Re: Stowe Mountain Resort Big Spruce Brook 1272 Order

**STOWE MOUNTAIN RESORT
IRON SEEP REMEDIATION PLAN
GOLF COURSE CLUBHOUSE VICINITY**

Re: Stowe Mountain Resort Big Spruce Brook 1272 Order:

Stowe Mountain Resort
Proposed Iron Seep Remediation Plan
Golf Course Clubhouse Vicinity

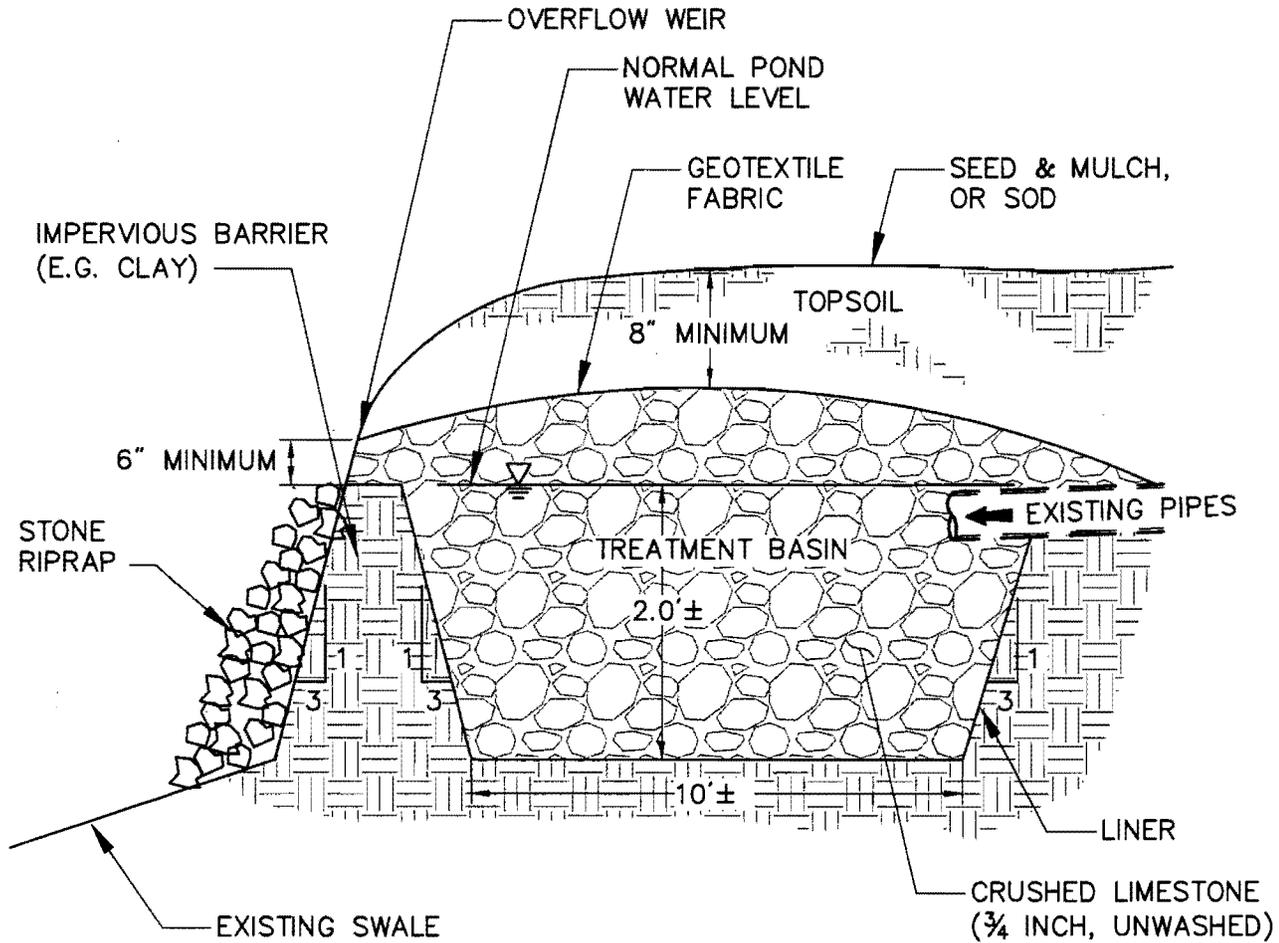
1. Addressing the groundwater iron seep using the proposed remediation plan as presented in VHB Pioneer's Stowe Mountain Resort Iron Seep Remediation Plan Golf Course Clubhouse Vicinity is acceptable as proposed. However, we request that the weekly post-construction visual observations be submitted to us electronically as a quarterly summary.

OVERALL
STORM DRAIN
REALIGNMENT
SITE PLAN

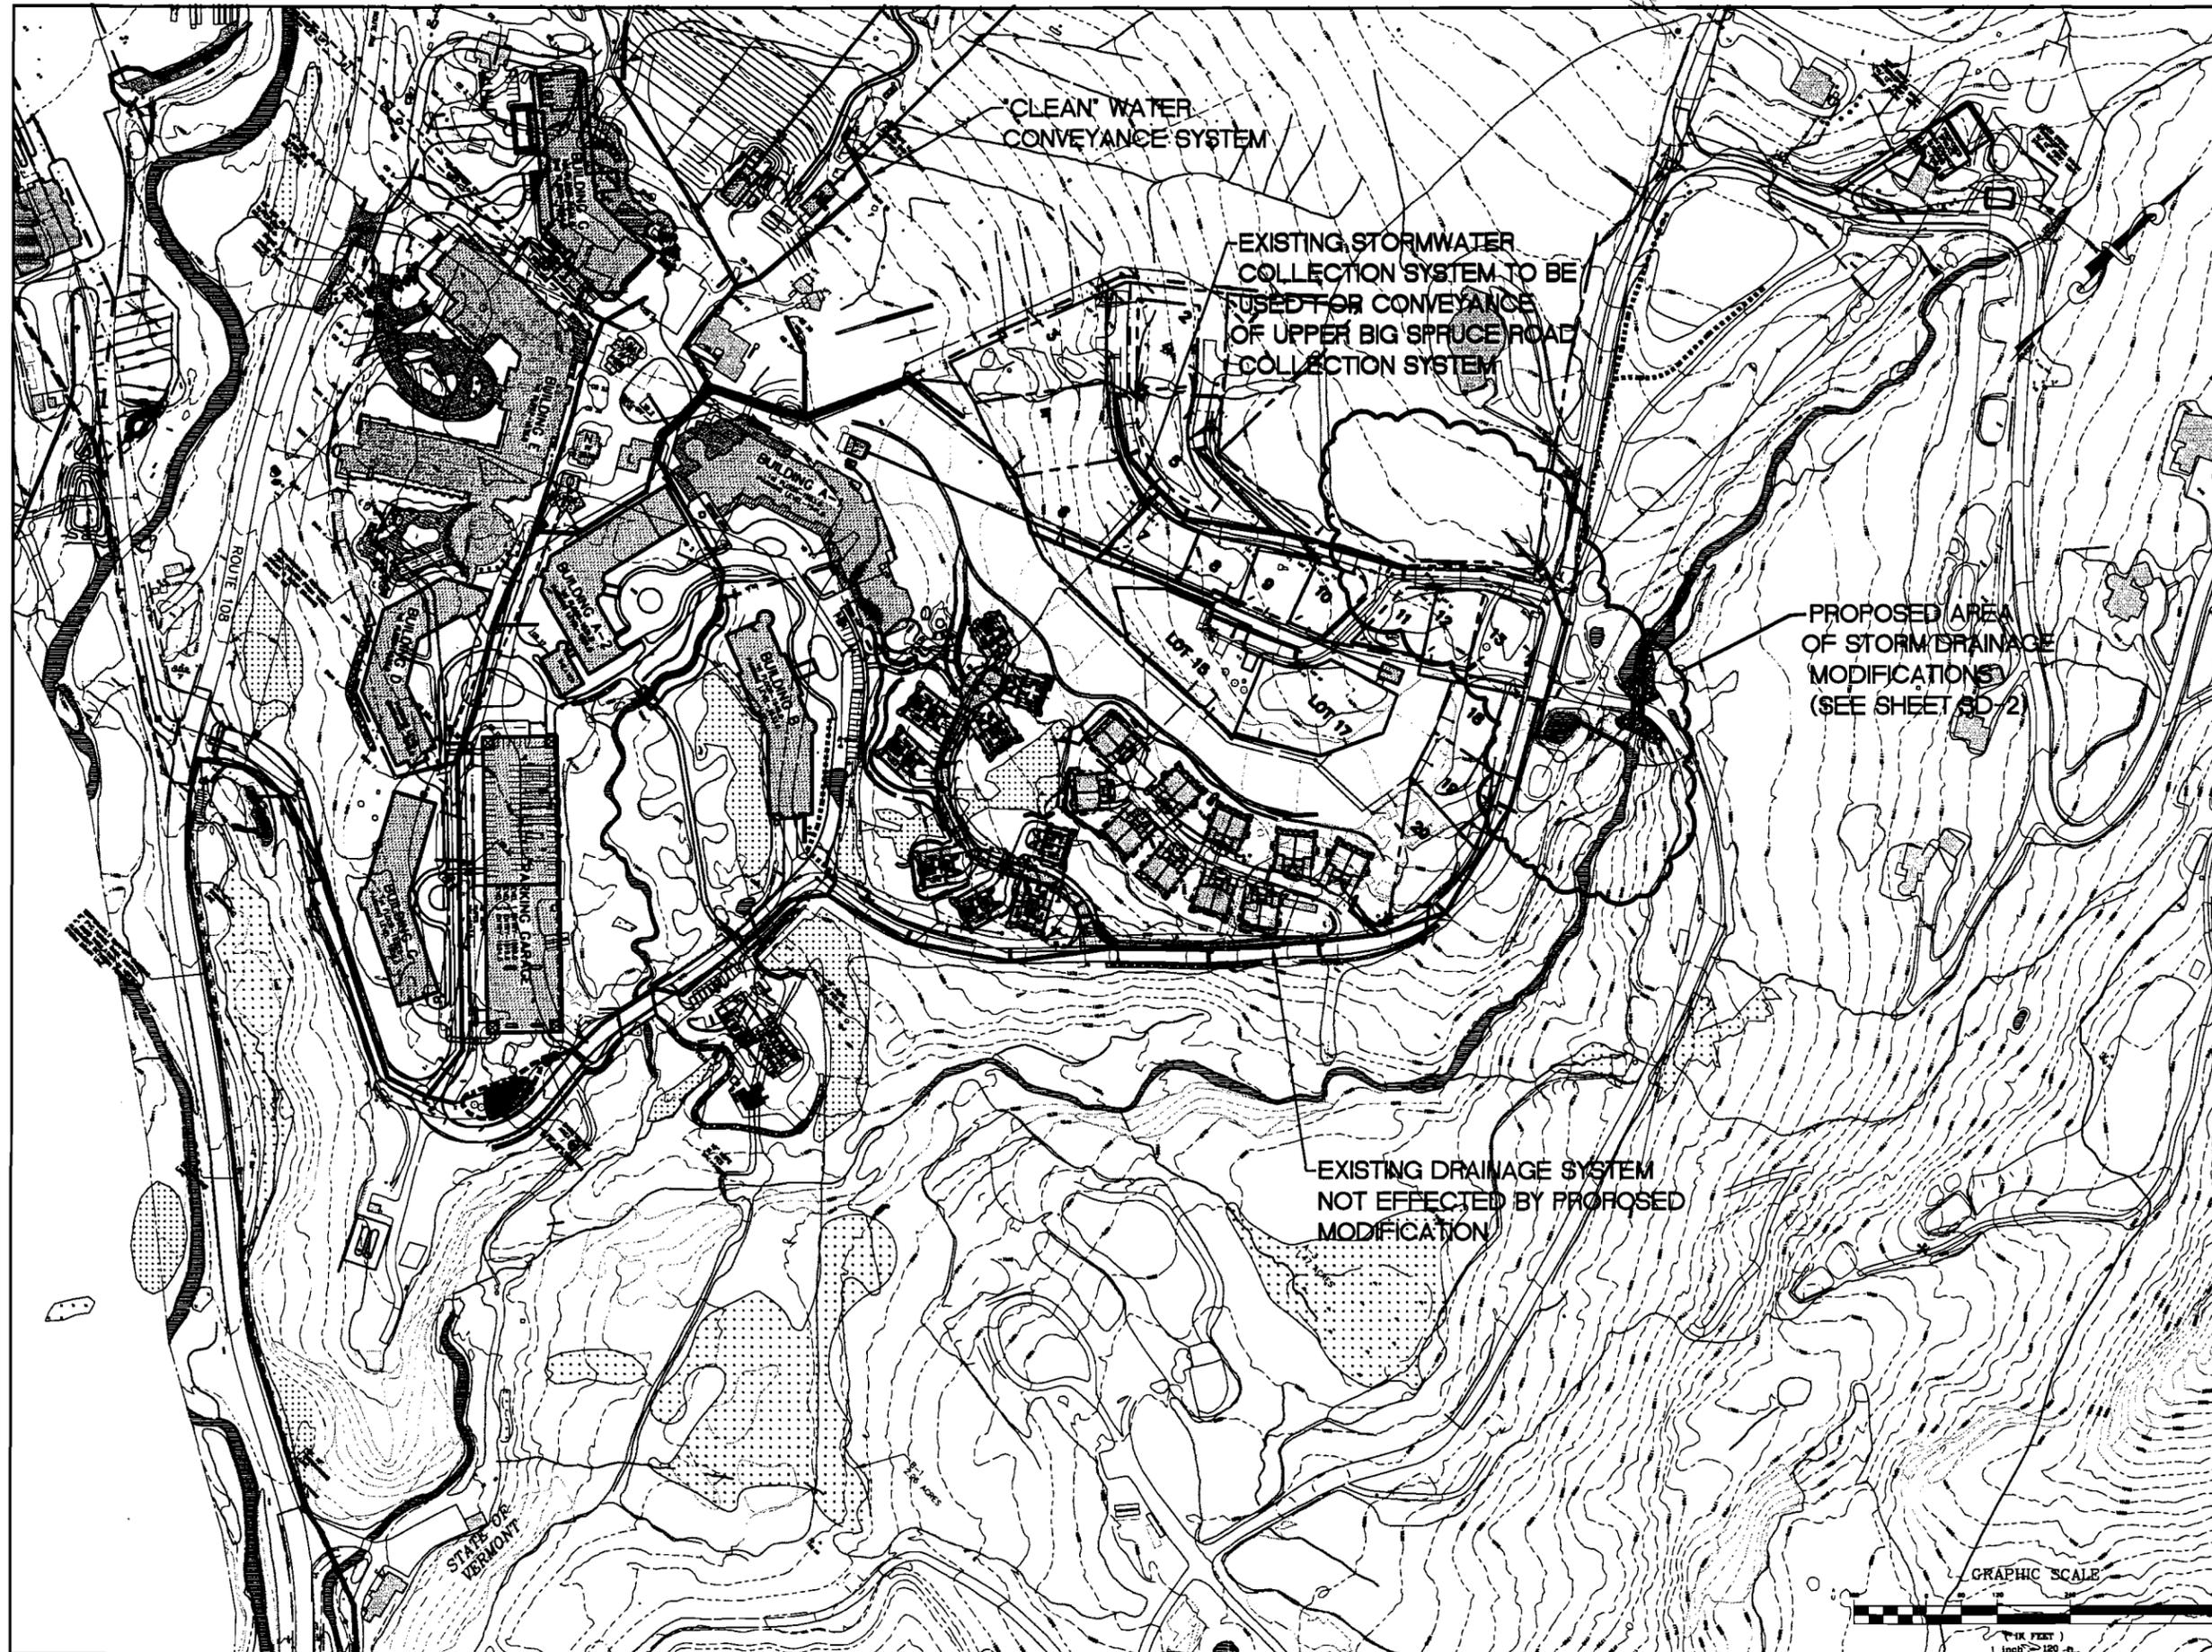
3. We request that the proposed plan to lower the impacts of sediment into Big Spruce Brook be amended to include the following components:
 - a) Stormwater runoff from Big Spruce Road should be collected on both sides of the road before being collected at National Drive. Currently only the east side of road is being collected and treated. The runoff from the west side of the road discharges to the brook that runs alongside the roadway without sufficient treatment. A roadside ditch with a permanent check dam system, or stone lined waterway, designed according to the Vermont Standards and Specifications for Erosion Prevention and Sediment Control should be included for both sides of the road.

- b) Please evaluate whether the Spruce Hamlet stormwater collection and treatment system can accommodate the additional flows within the permitted design capacity.

- c) The culvert that crosses under the driveway to the Ski Club should be eliminated to avoid co-mingling of roadway runoff and the stream.
